TN05 – LLFA Comment Response (4)

Site: Land East of Mousdell Close, Ashington
Prepared by: Phil Allen MCIWEM C.WEM
Approved by: Jason Morgans
Date: 9 February 2026

**DC/25/1327 Land East of Mousdell Close Rectory Lane Ashington RH20 3GS
Erection of 74 dwellings with associated access, parking, and landscaping.**

Extended Topographic Survey

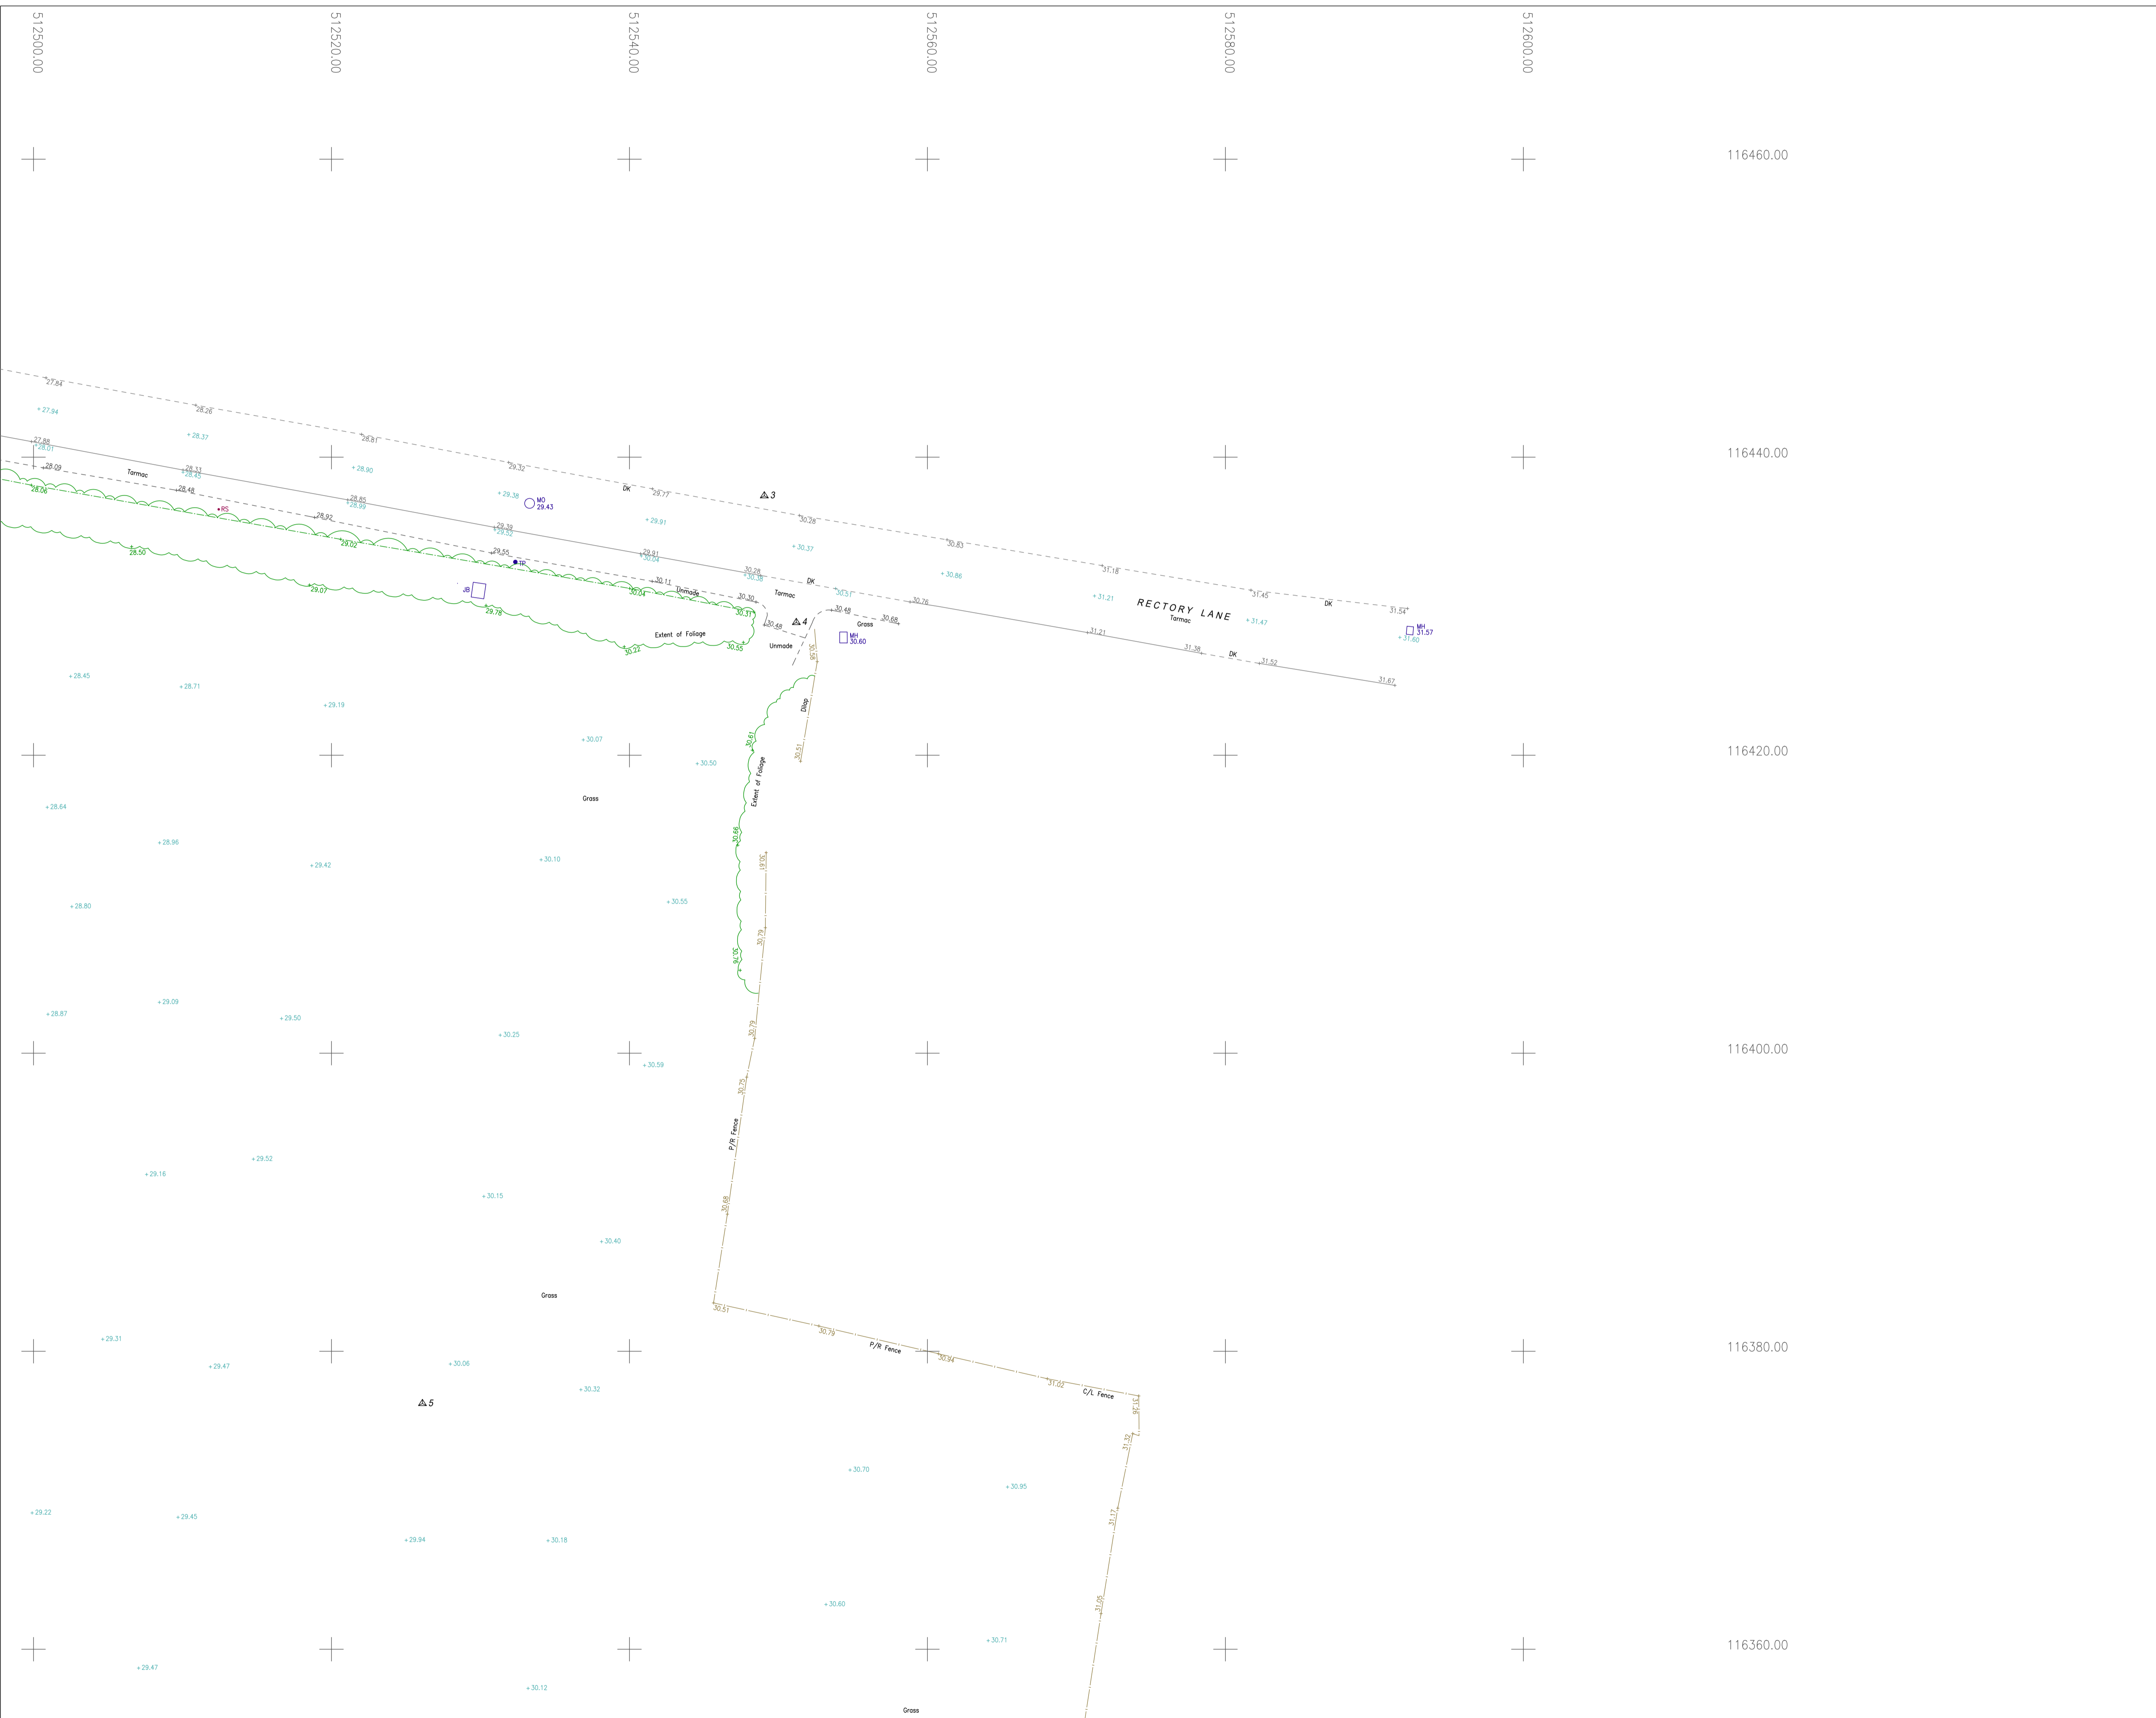
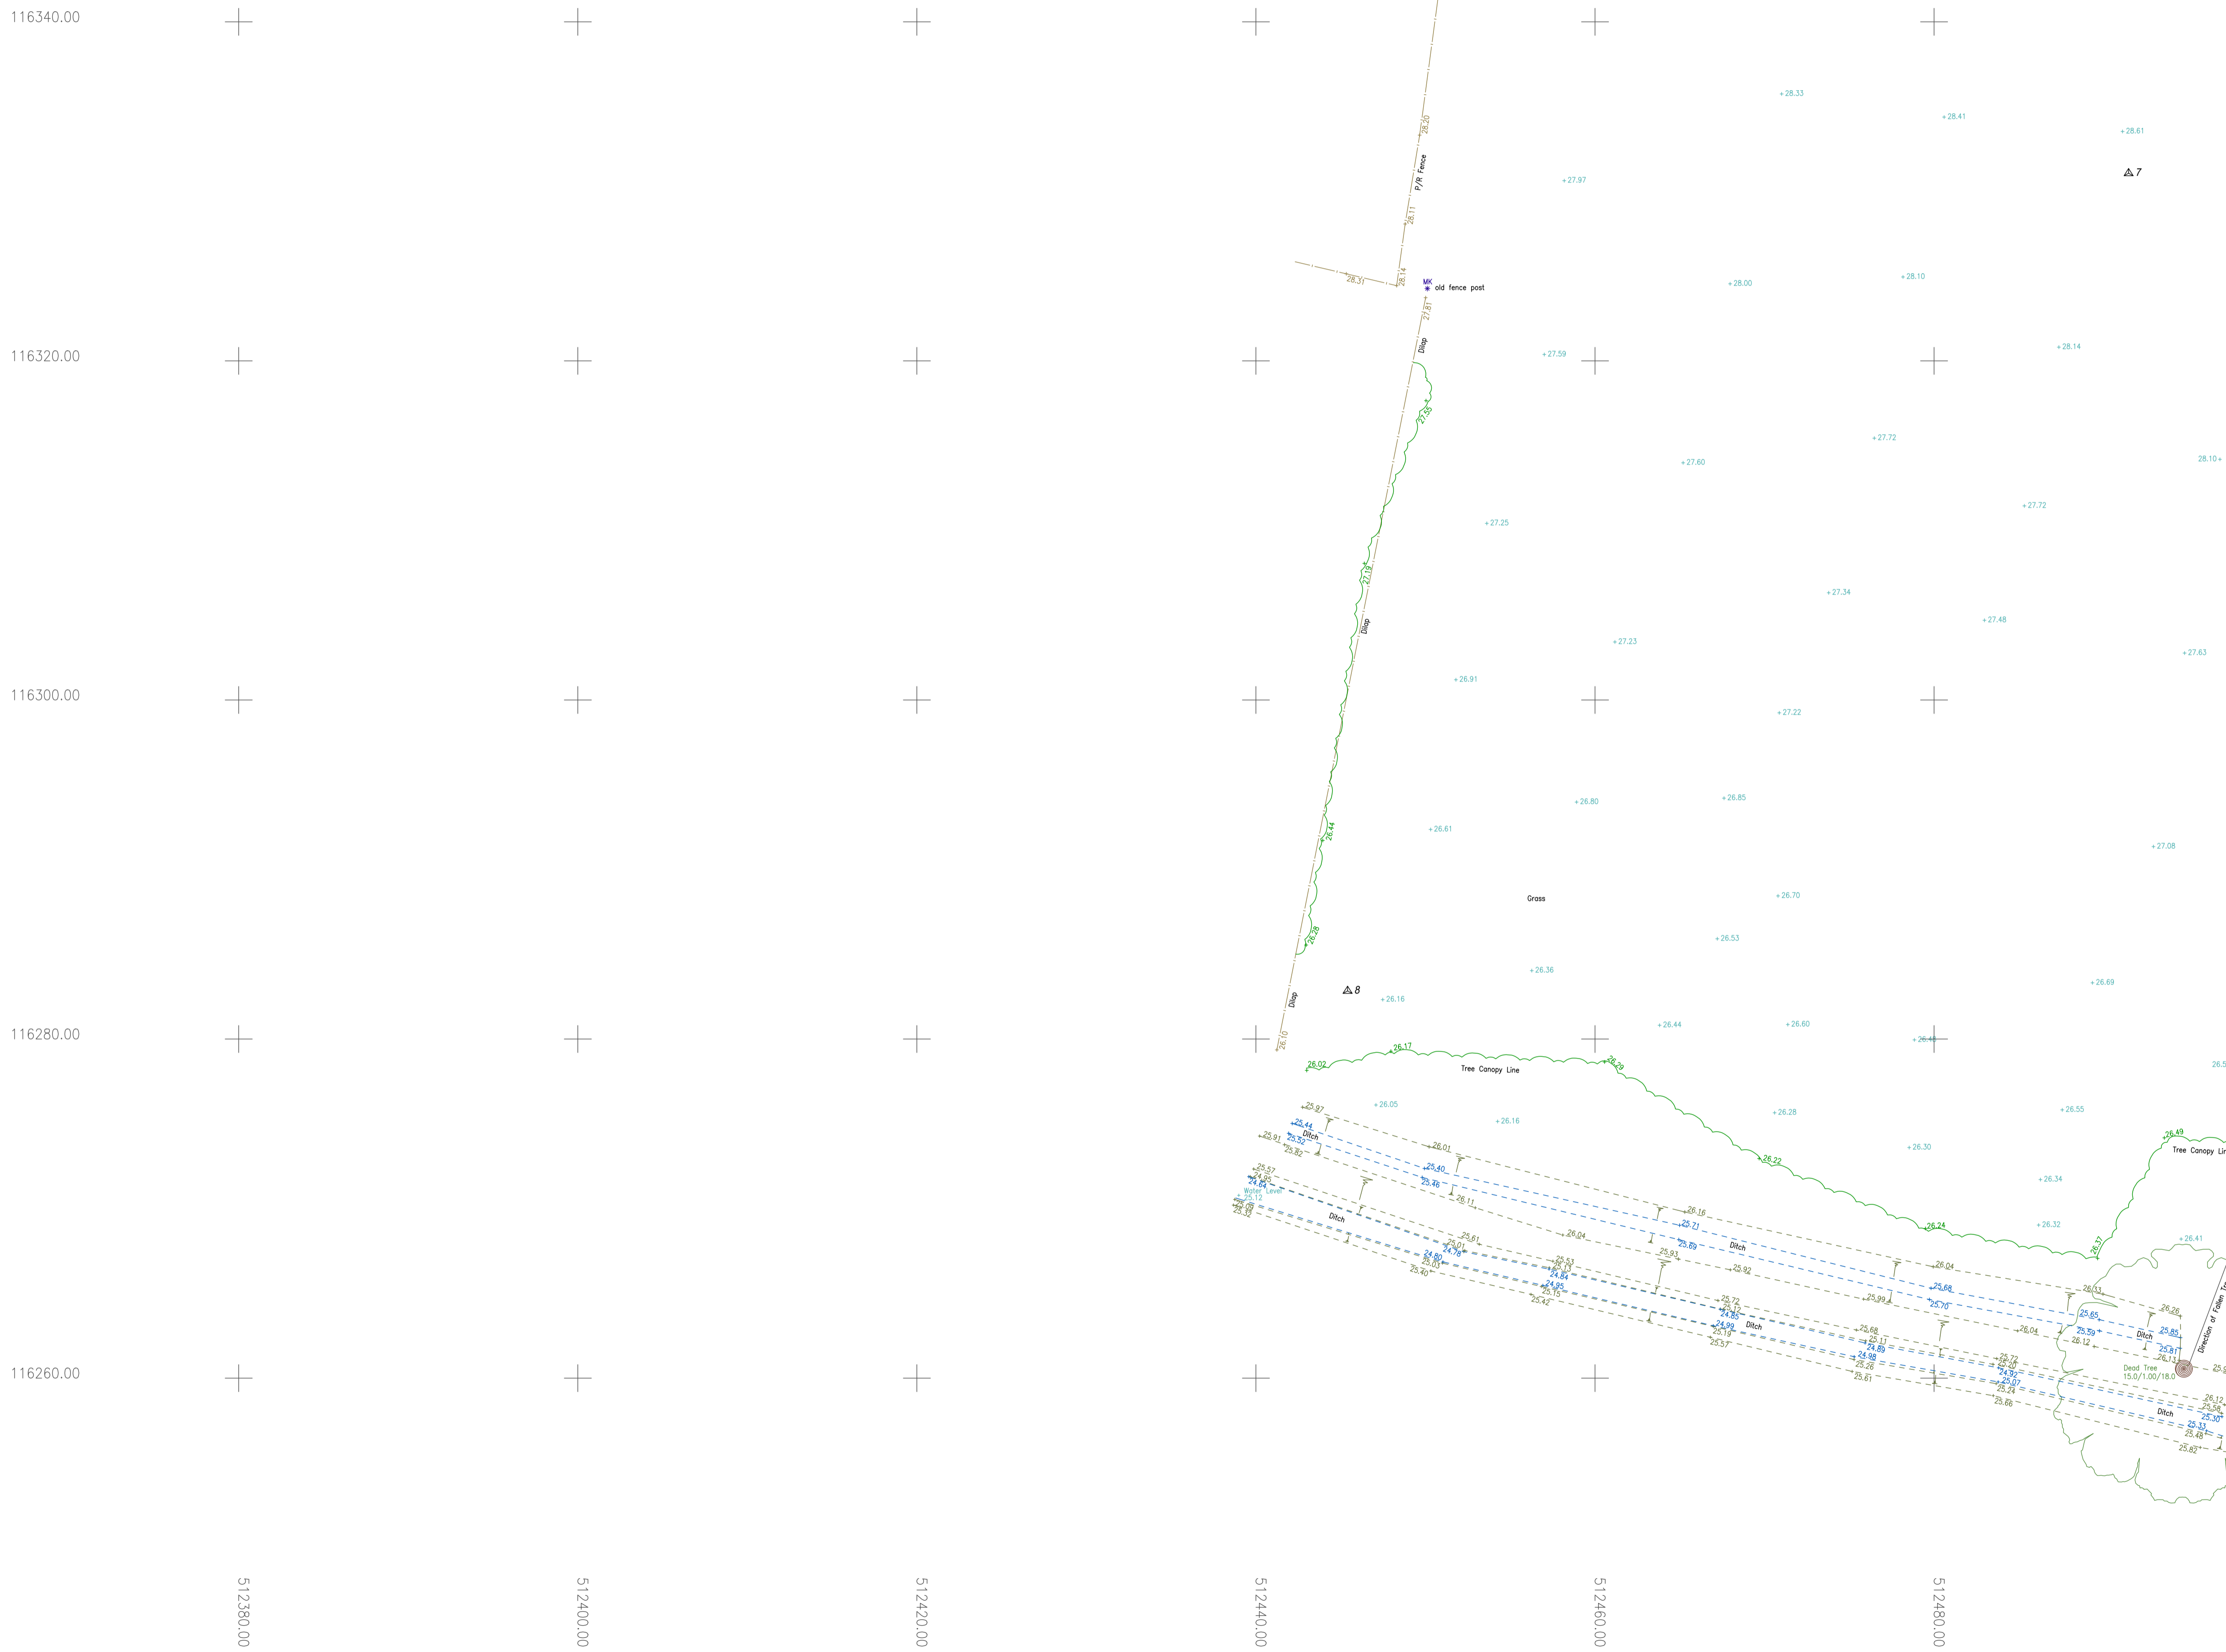
- a) The current drainage layout only shows an outfall and not the receiving watercourse. An invert level for that outfall is given (25.80), but no existing silt levels, hard-bed levels, or bank-top levels are provided for the receiving watercourse, so it is unclear if this is a viable point of discharge. As I have previously stated the viability of the SuDS scheme is wholly reliant on there being a suitable discharge location. Therefore, I would like to repeat my request for both the path and levels of the receiving watercourse to be detailed on the drainage layout (to enable me to appraise the suitability/viability of the discharge point).

- b) I also need to understand the condition of the section of the receiving watercourse where the developer/landowner has riparian responsibilities (particularly downstream of the proposed SuDS outfall). This is to ensure the discharge can be appropriately conveyed on downstream (rather than escaping the confines of the watercourse, due to blockages, and causing flooding on third party land). This is of particular concern given the photographs, submitted by others, which suggest that this watercourse may be significantly obstructed. (Note: At no point have I suggested that the developer is required to undertake works to clear sections of this watercourse beyond their riparian responsibilities. I assume the images in question relate to the section of this watercourse under the developer/landowner's control, if they do not; then developer would not be required remediate those problems. Had the current silt levels, hard-bed levels, and bank levels of the receiving watercourse, where it abuts the site, been included on the proposed drainage layout the current situation, and any need for maintenance interventions, would have been much clearer).

- 2.1 A survey of the receiving watercourse has been carried out, and this can be seen in [Appendix B](#). This survey shows the silted levels, hard bed levels and bank top levels of the receiving watercourse.

- 2.2 This survey shows that the silted and hard-bed levels are below that of the original outfall specified in the drainage strategy (25.80mAOD), thus the survey has demonstrated that the watercourse is viable for a gravity outfall. The survey also shows that there is a consistent gradient across the watercourse bed levels and that there are no blockages.
